Newtex Knit Fashion Ltd.

24th May 2014

Building Observations

Column & Beam Strengthening

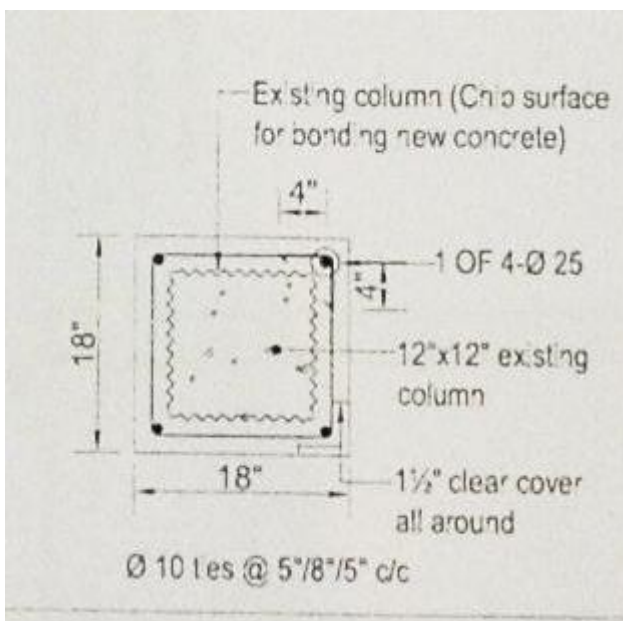
**High stress levels in columns/cantilevered
concrete slabs.**

Cantilever
↔

Item No.	Observation	Recommended Action Plan	Recommended Timeline
1	High stress levels in cantilevered concrete slab/perimeter columns	Building Engineer to confirm by calculation the adequacy of the perimeter columns to carry the loading from the cantilevered elements in the building	6-weeks
2	Additional floor build ups and wall loadings at roof level	Building Engineer to confirm the adequacy of the structure to support the additional screeds, walls etc. at roof level.	6-months
3	Strengthening of Columns/Beams	Building Engineer to confirm that the reinforcement cover to the top of the beam strengthening is adequate and that the welding of the new bars to the underside of the link is structurally adequate.	6-months
4	Cracking in Beams	Building Engineer to confirm that the cracking in beam elements is non-structural.	6-weeks
5	Cracking in Beams	Building Engineer to monitor cracking on an on-going basis.	6-months

Column Strengthening

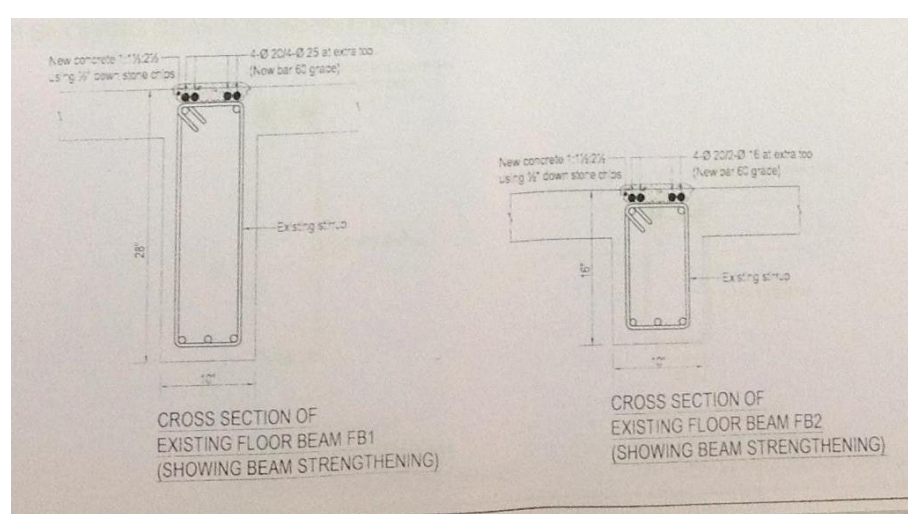
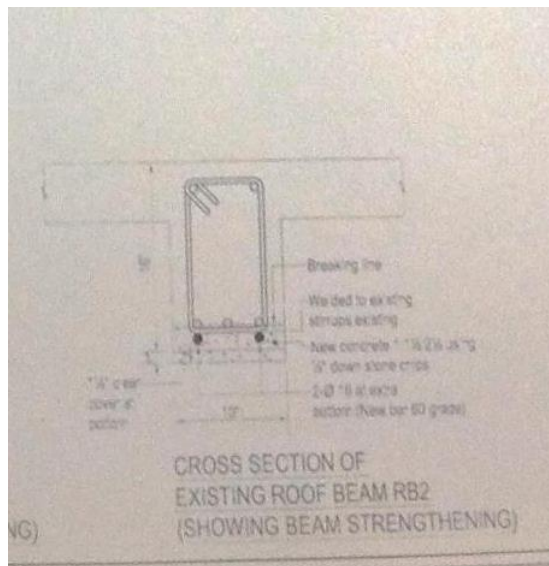
Beam Strengthening (has cover to top reinforcement been compromised?)

Beam Strengthening (new bar welded to link, is weld adequate?)

Lighter floor colouring
Is where beam
strengthening has
occurred.

Large Build up on Roof

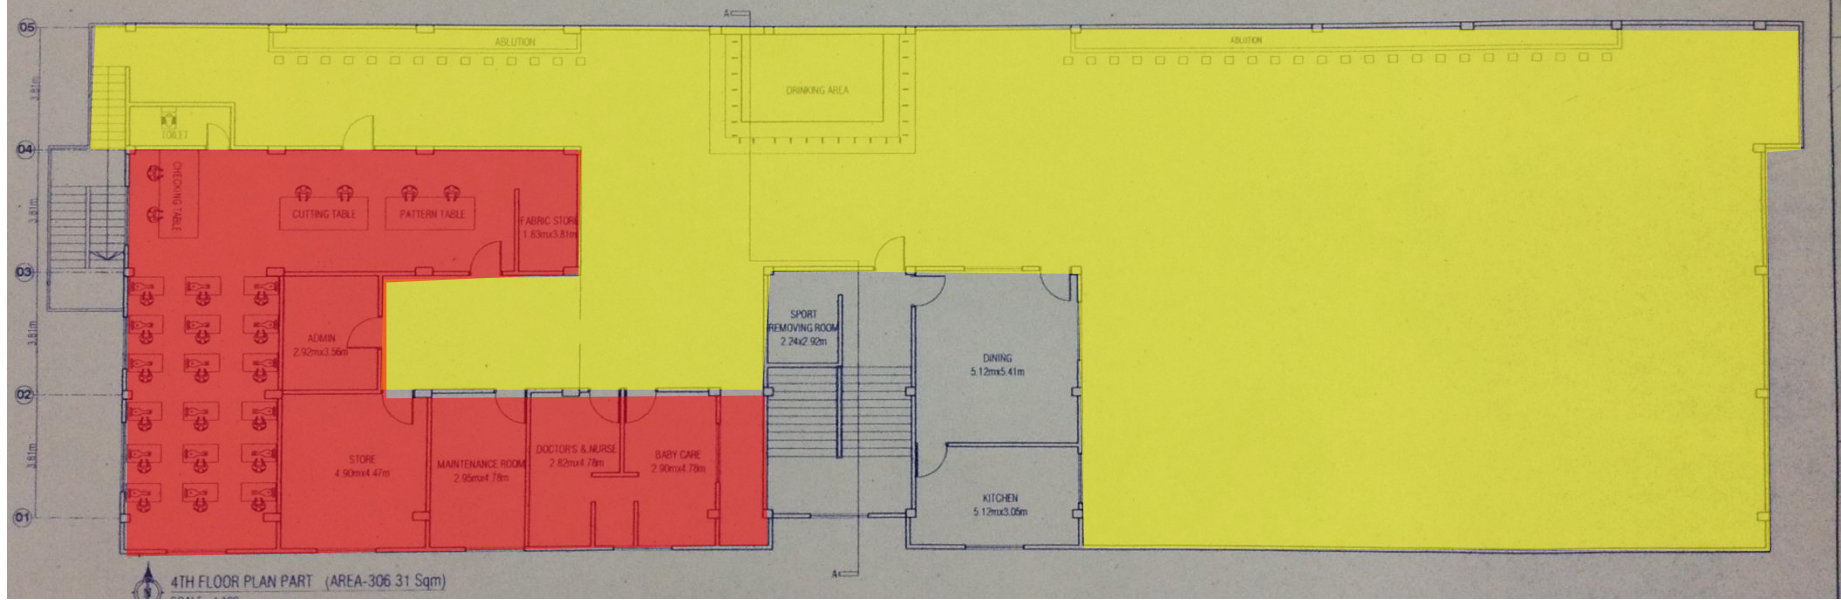
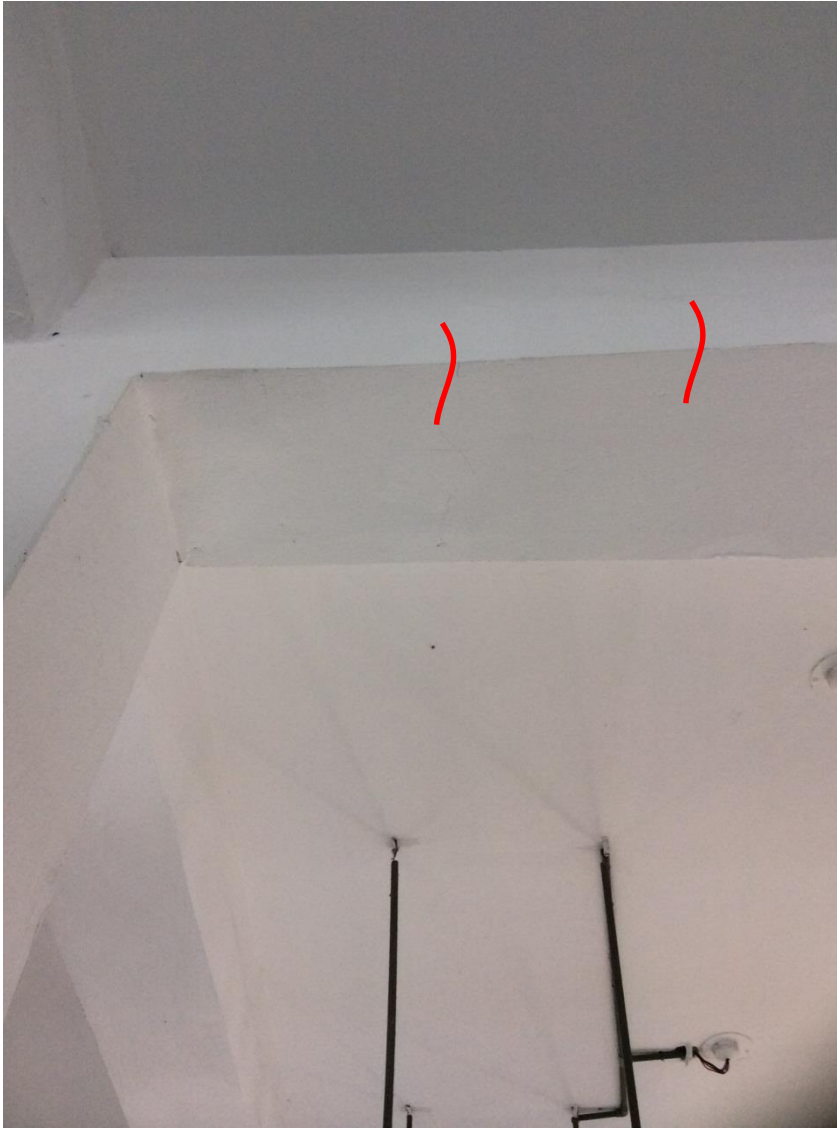
65mm Build Up at roof Level

Additional 60mm Build Up at roof Level

Additional 90mm Build Up In toilet area at roof level.

Discrepancies between Loading Plan and Drawings/Actual Observations

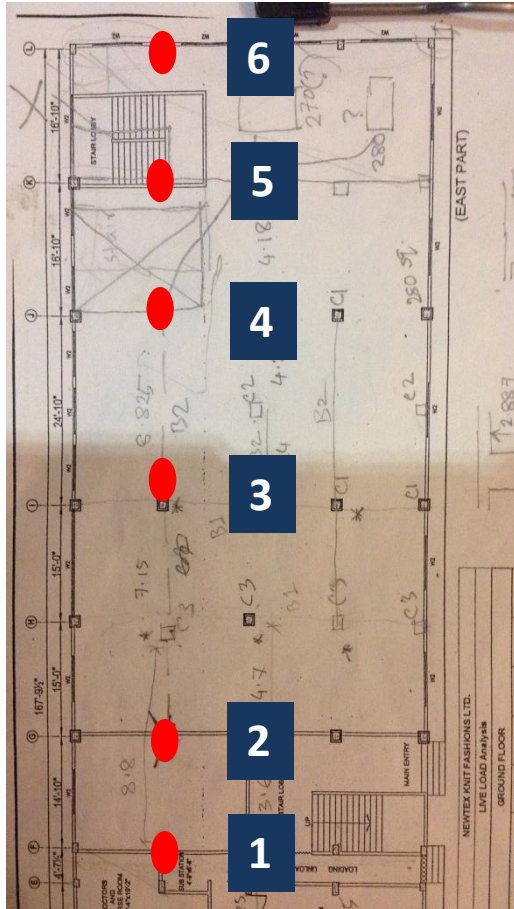
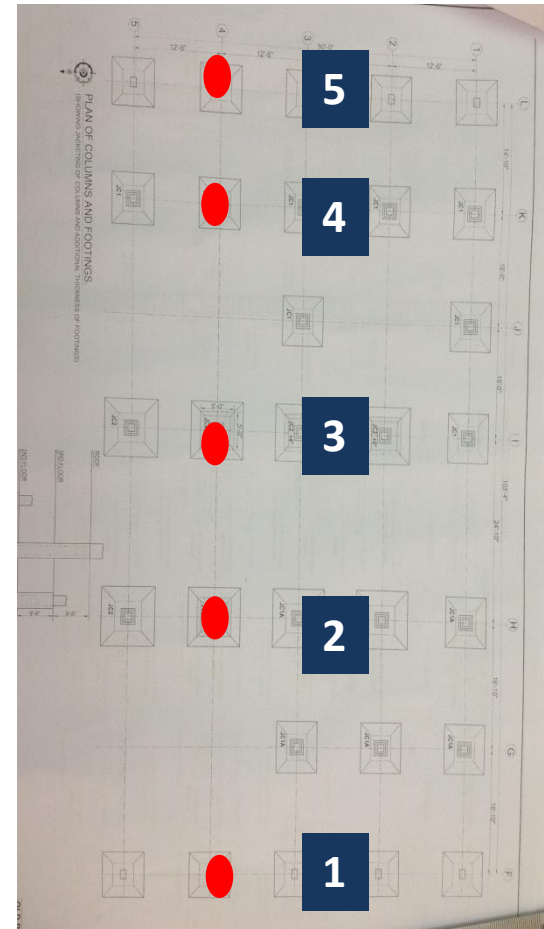
There is an additional grid/column line in the loading plan compared to structural Layout and actual observations

6	Discrepancies between loading plan and as built structure	Building engineer to check the adequacy of the existing structure to take the loading from the as built structure.	6-months
7	Discrepancies between loading plan and as built structure	Building engineer to implement load management plan.	6-months
8	Discrepancies between loading plan and as built structure	Continue to implement load management plan	6-months
9	Non-engineered steel/Bamboo Dining area	Lightweight structure to be reconstructed/upgraded to ensure adequacy for code vertical and wind loads by the Building Engineer.	6-months
